Prairie Island Nuclear Generating Plant

License Amendment Request Dated June 11, 1993

Proposed Changes Marked Up
On Existing Technical Specification Pages

Revised Technical Specification Pages

FIGURE TS.3.8-1 Spent Fuel Pool Unrestricted Region Minimum Burnup Requirements

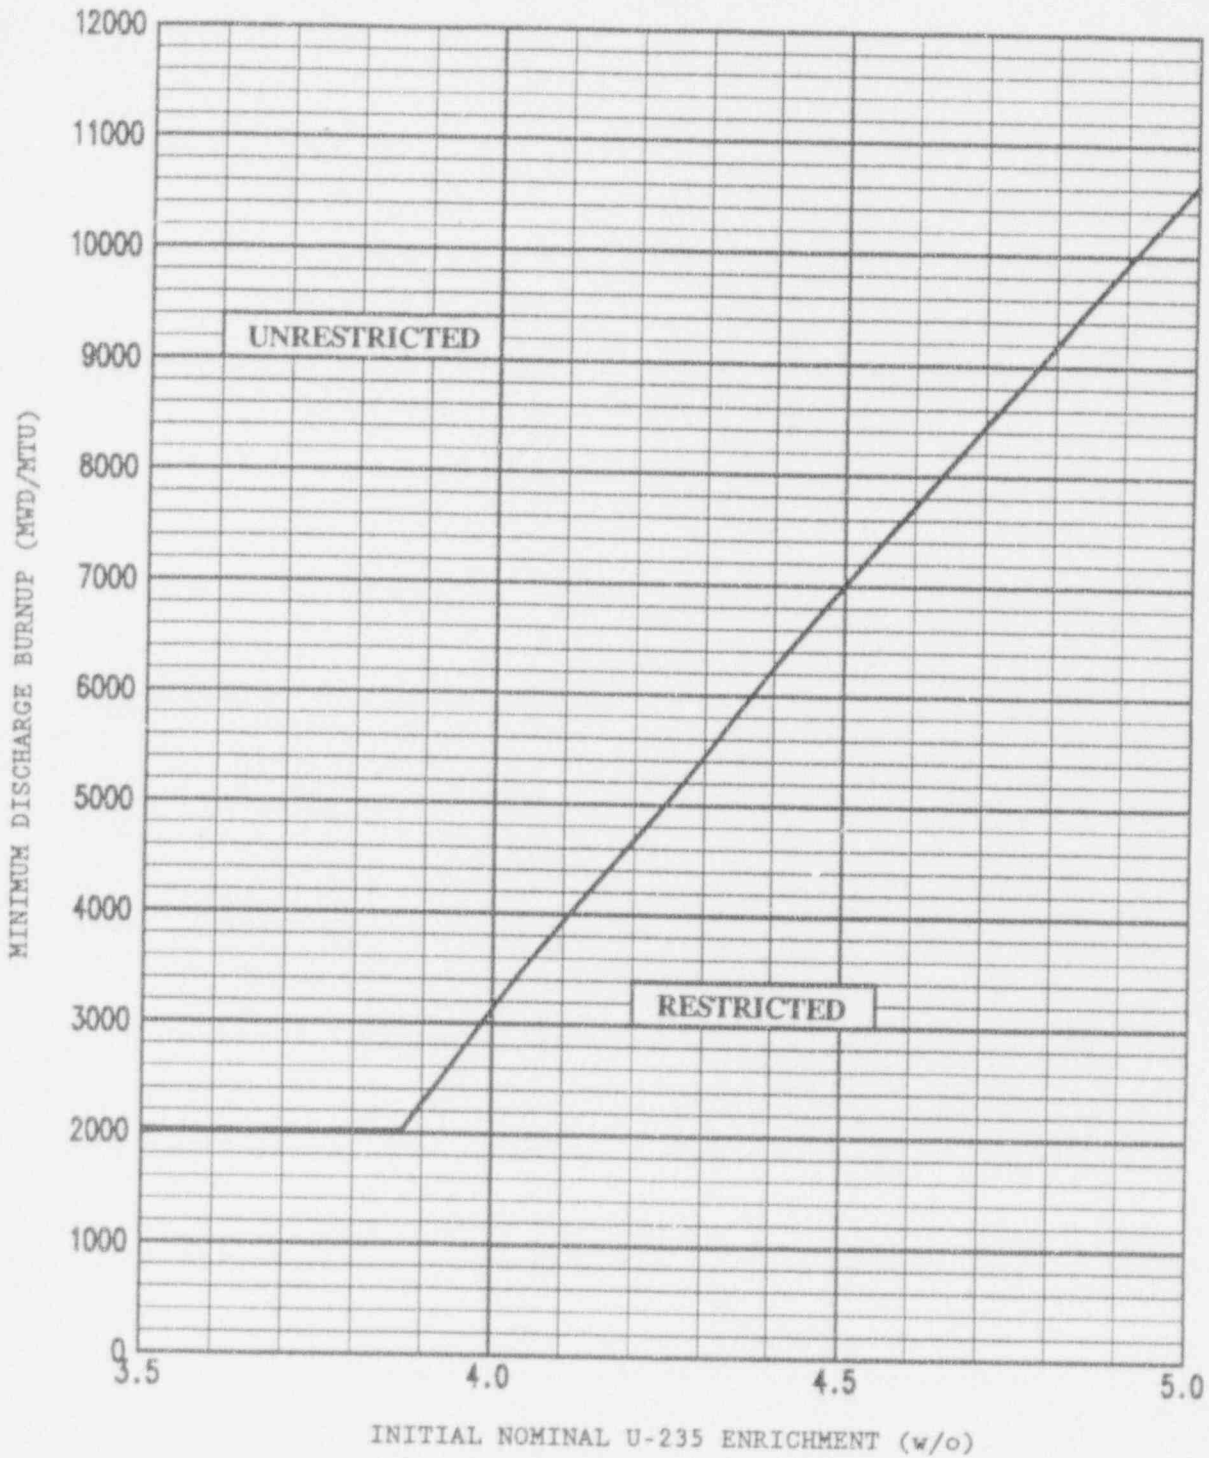
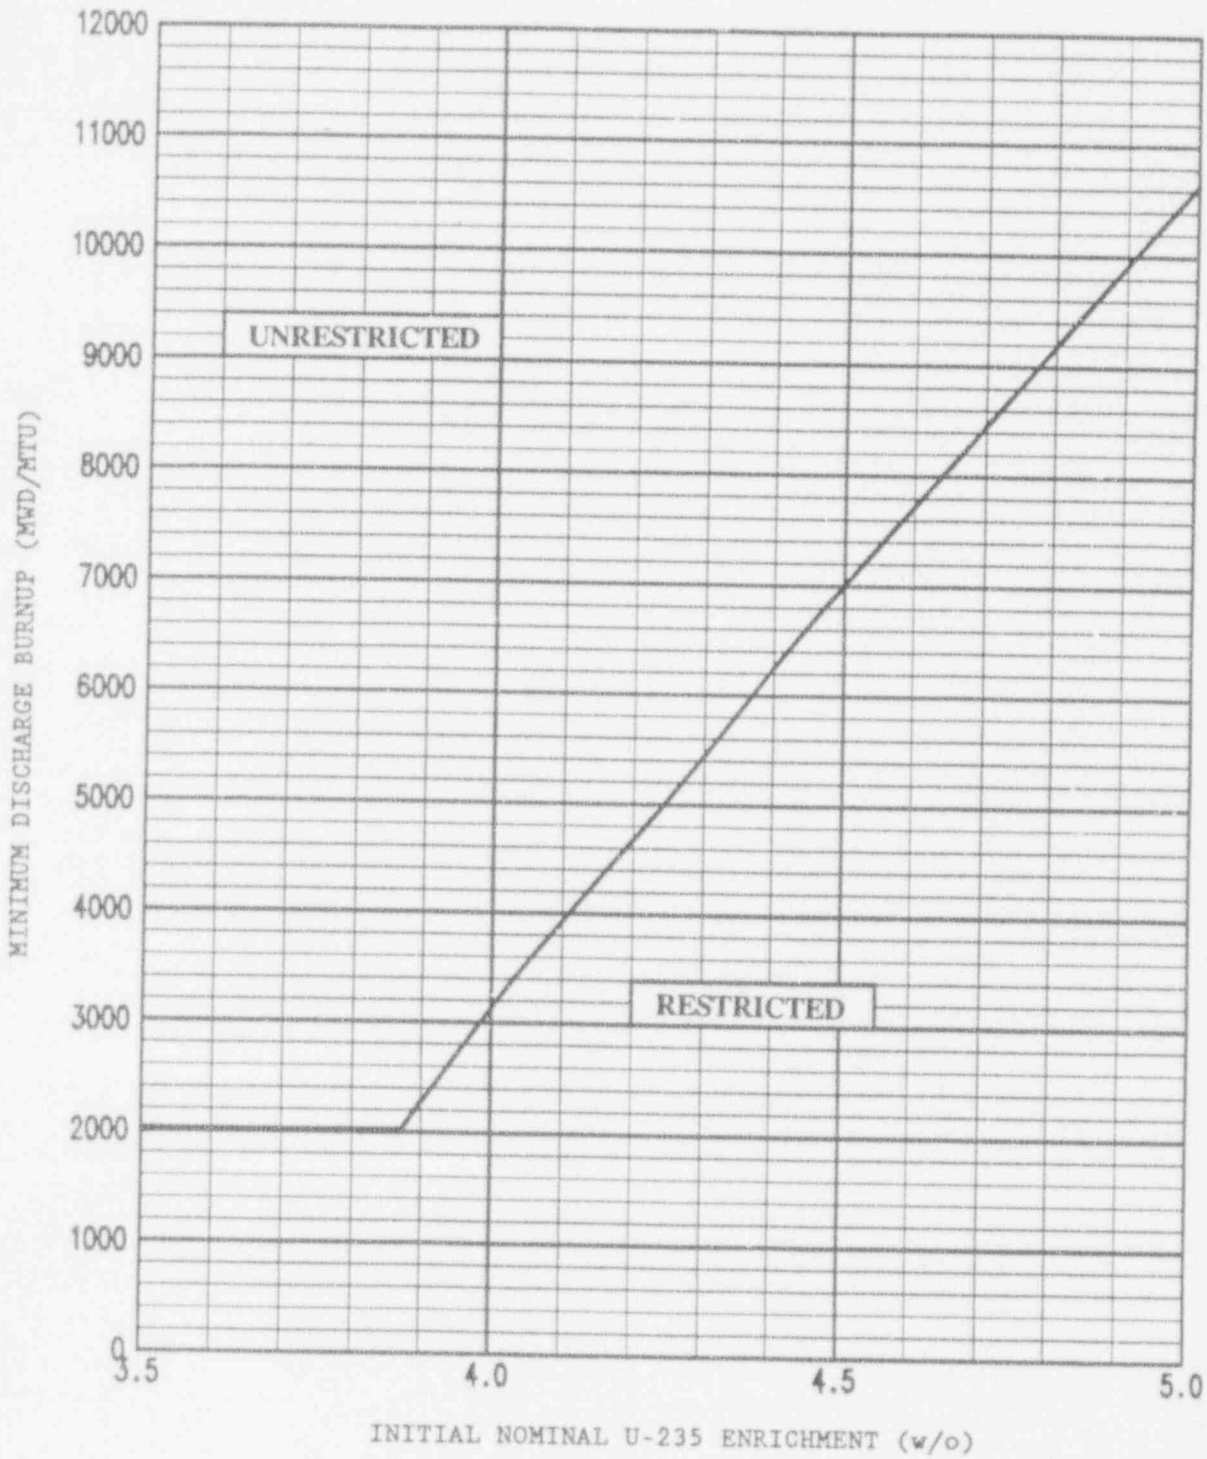
- a. To be stored without restriction in the spent fuel pool, the burnup and initial enrichment of a fuel assembly shall be within the unrestricted range of Figure TS.3.8-1.
- b. Fuel assemblies with a combination of burnup and initial enrichment in the restricted range of Figure TS.3.8-1 shall be stored in accordance with Specification 5.6.A.1.d.
- c. If the requirements of 3.8.E.1.a and 3.8.E.1.b are not met, immediately initiate action to move any noncomplying fuel assembly to an acceptable location.
- d. The provisions of Specification 3.0.C are not applicable.

- d. New or spent fuel assemblies with a combination of burnup and initial enrichment in the restricted range of Figure TS.3.8-1 stored in compliance with Figures TS.5.6-1 and TS.5.6-2.

Figure TS.3.8-1, which specifies the minimum burnup requirements for unrestricted storage in the spent fuel pool, is based on enrichments from 3.87 to 5.0 weight percent U-235. Enrichments lower than 3.87 weight percent are conservatively bounded by the minimum burnup requirement for 3.87 weight percent U-235 which is 2000 MWD/MTU. Therefore, Figure TS.3.8-1 has been drawn to require that fuel with an initial enrichment of less than 3.87 weight percent U-235 have 2000 MWD/MTU burnup or greater before unrestricted storage in the spent fuel pool will be allowed.

1. Fuel Assembly Storage
 - a. To be stored without restriction in the spent fuel pool, the burnup and initial enrichment of a fuel assembly shall be within the unrestricted range of Figure TS.3.8-1.
 - b. Fuel assemblies with a combination of burnup and initial enrichment in the restricted range of Figure TS.3.8-1 shall be stored in accordance with Specification 5.6.A.1.d.
 - c. If the requirements of 3.8.E.1.a and 3.8.E.1.b are not met, immediately initiate action to move any noncomplying fuel assembly to an acceptable location.
 - d. The provisions of Specification 3.0.C are not applicable.

Figure TS.3.8-1, which specifies the minimum burnup requirements for unrestricted storage in the spent fuel pool, is based on enrichments from 3.87 to 5.0 weight percent U-235. Enrichments lower than 3.87 weight percent are conservatively bounded by the minimum burnup requirement for 3.87 weight percent U-235 which is 2000 MWD/MTU. Therefore, Figure TS.3.8-1 has been drawn to require that fuel with an initial enrichment of less than 3.87 weight percent U-235 have 2000 MWD/MTU burnup or greater before unrestricted storage in the spent fuel pool will be allowed.

FIGURE TS.5.6-1 Spent Fuel Pool Burned/Fresh Checkerboard Cell Layout

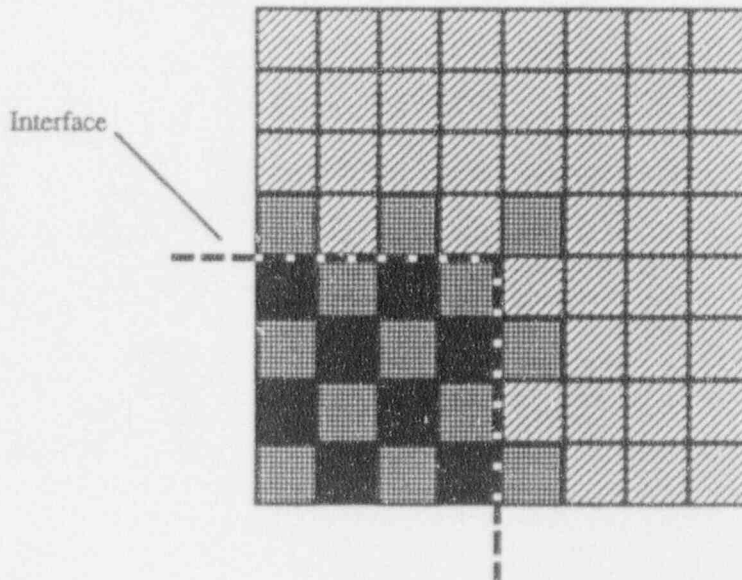
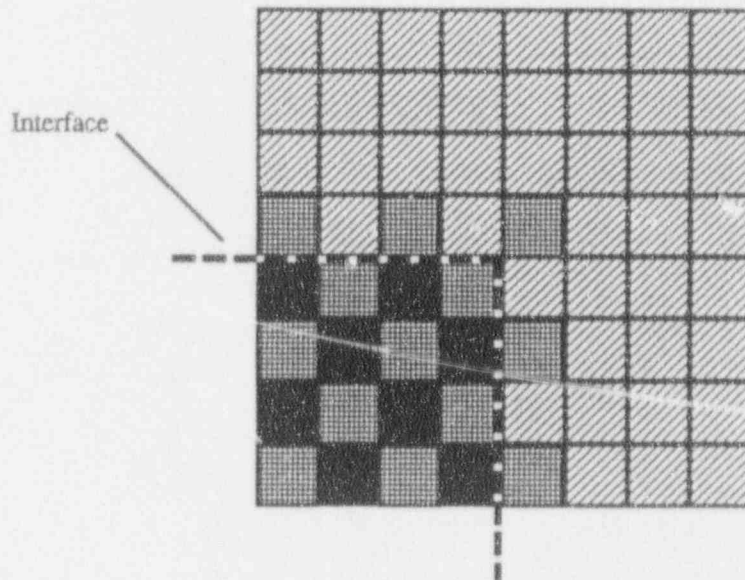
Note: The Checkerboard and unrestricted regions can alternatively be separated by a single row of vacant cells on each adjacent face.

1. separated by a vacant row of cells, or
2. the interface must be configured such that there is one row carryover of the pattern of burned assemblies from the checkerboard region into the first row of the unrestricted region (Figure TS.5.6-1).

- 
Fresh Fuel: Enrichments up to 5.0 w/o U-235, no restrictions on burnup
- 
Checkerboard Region Burned Fuel: Must satisfy minimum burnup requirements of Figure TS.5.6-2.
- 
Unrestricted Region Burned Fuel: Must satisfy minimum burnup requirements of Figure TS.3.8-1.

1. separated by a vacant row of cells, or
2. the interface must be configured such that there is one row carryover of the pattern of burned assemblies from the checkerboard region into the first row of the unrestricted region (Figure TS.5.6-1).

FIGURE TS.5.6-2 Spent Fuel Pool Checkerboard Region
Minimum Burnup Requirements

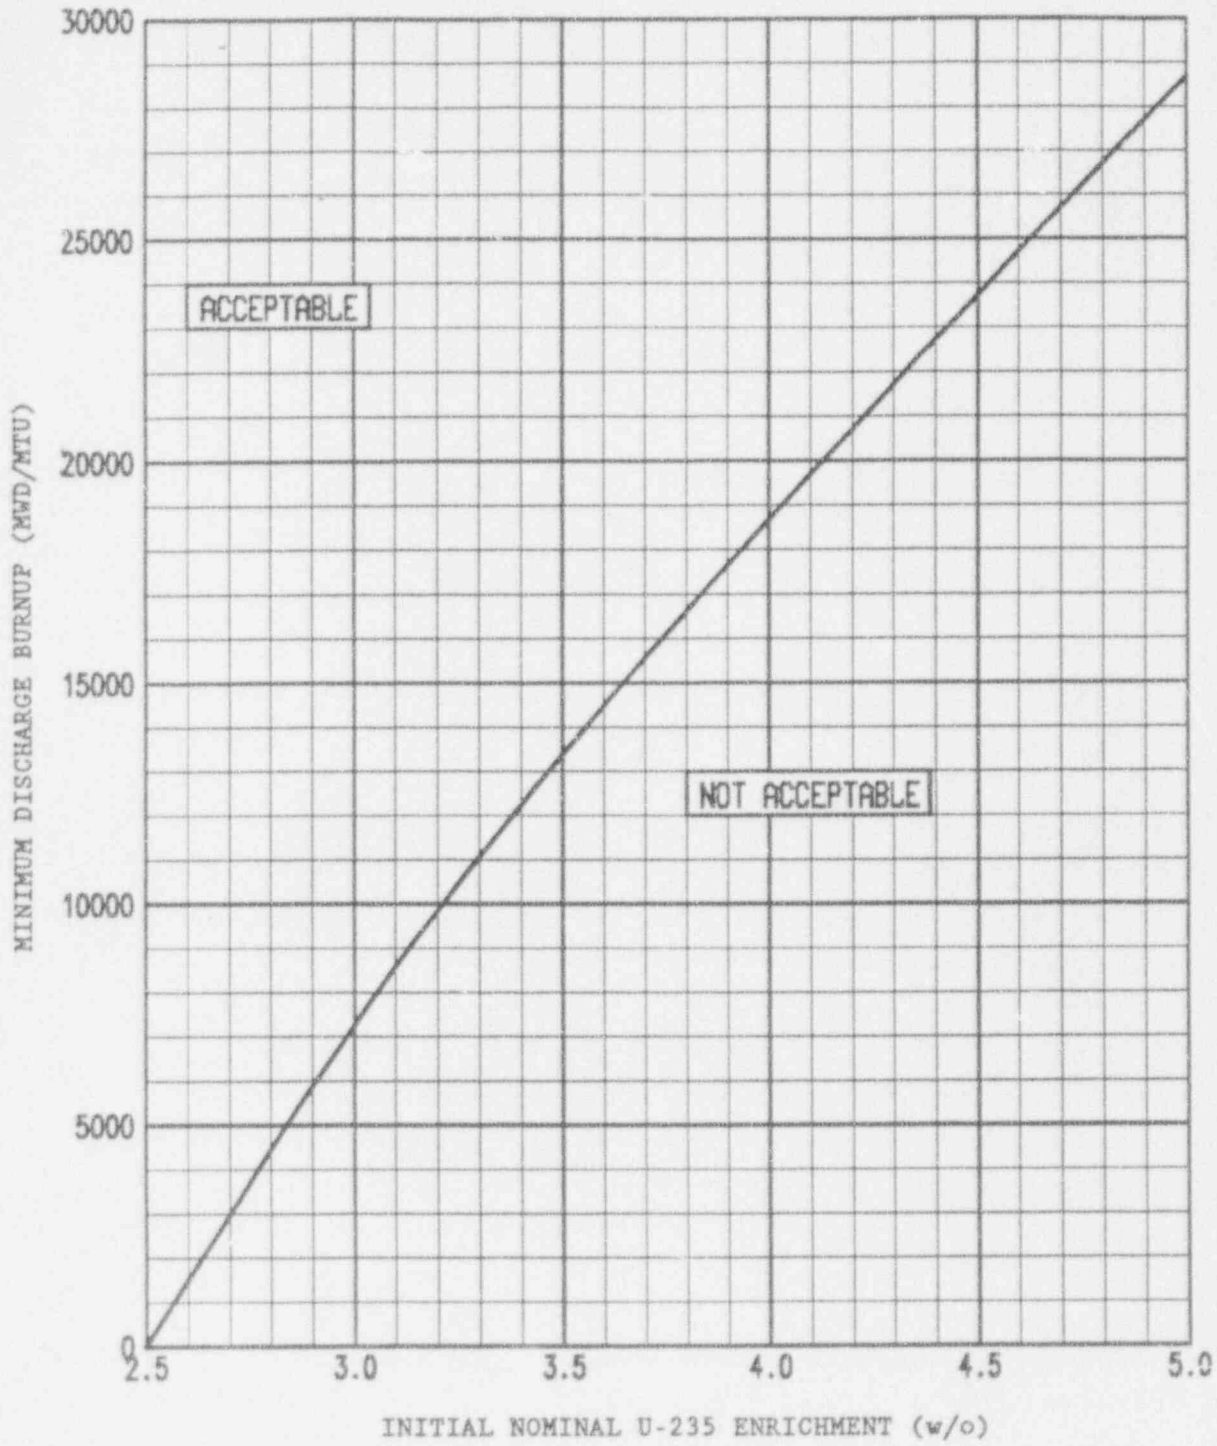
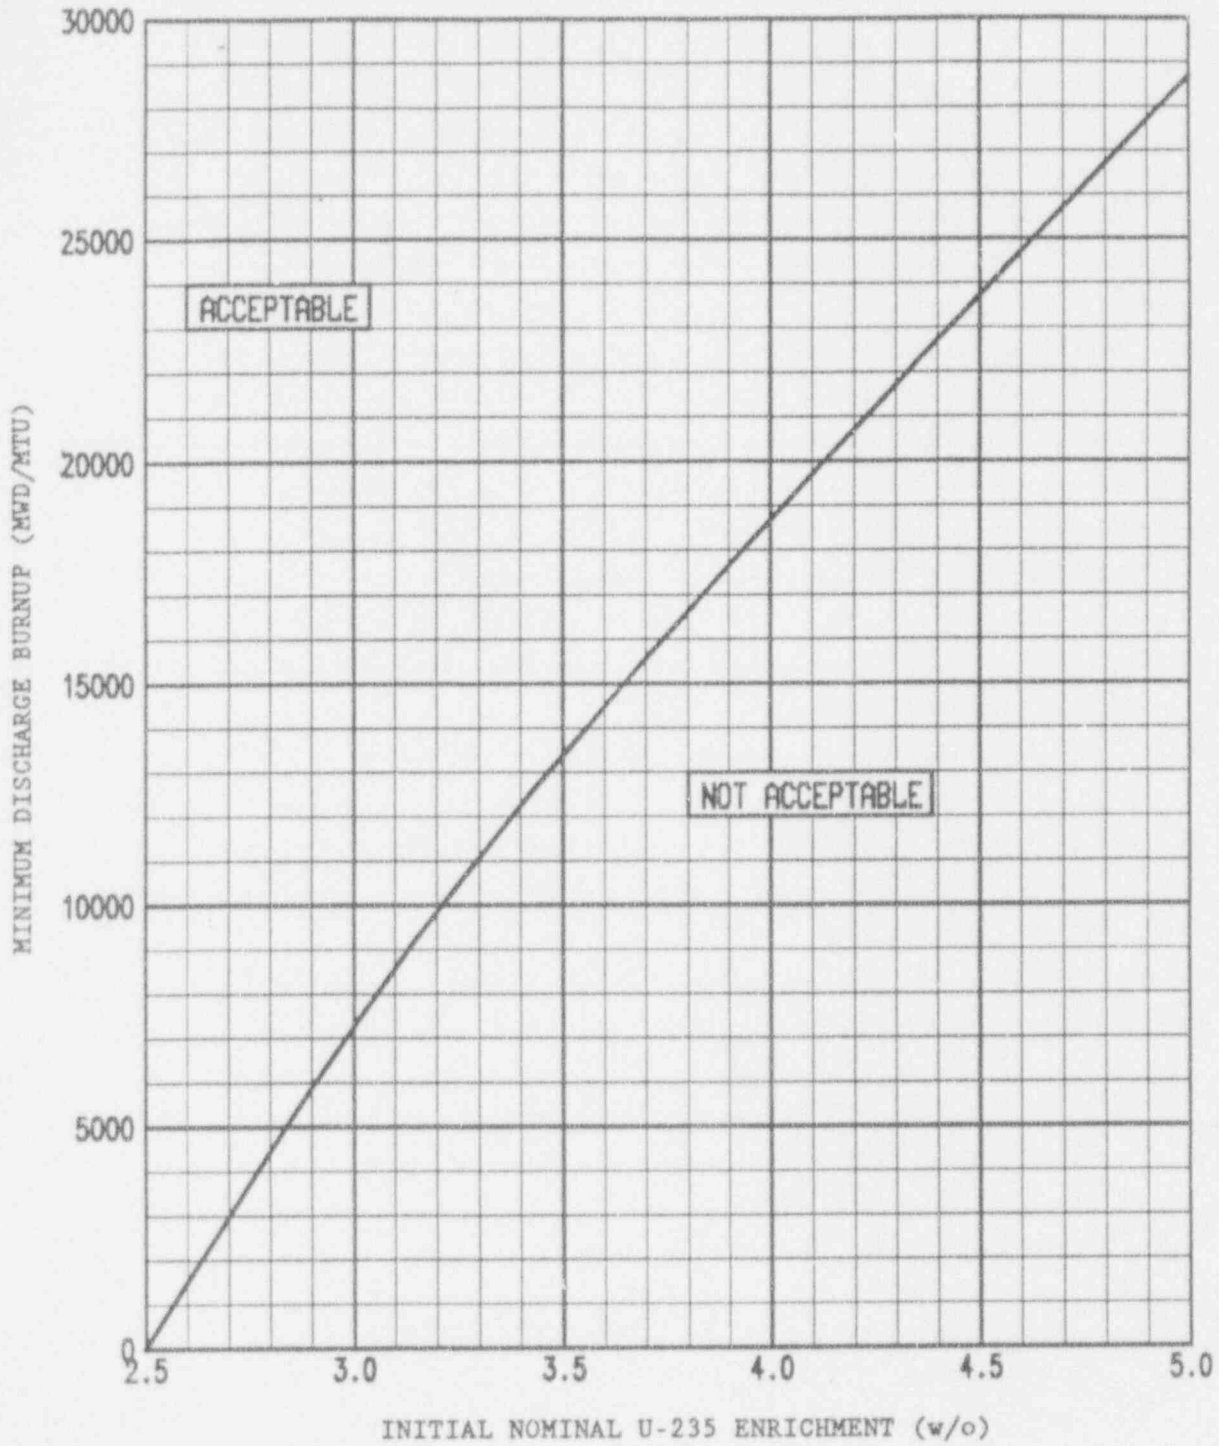
Burned Fuel: | Must satisfy minimum burnup requirements of Figure TS.5.6-2. |

- d. New or spent fuel assemblies with a combination of burnup and initial enrichment in the restricted range of Figure TS.3.8-1 stored in compliance with Figures TS.5.6-1 and TS.5.6-2.
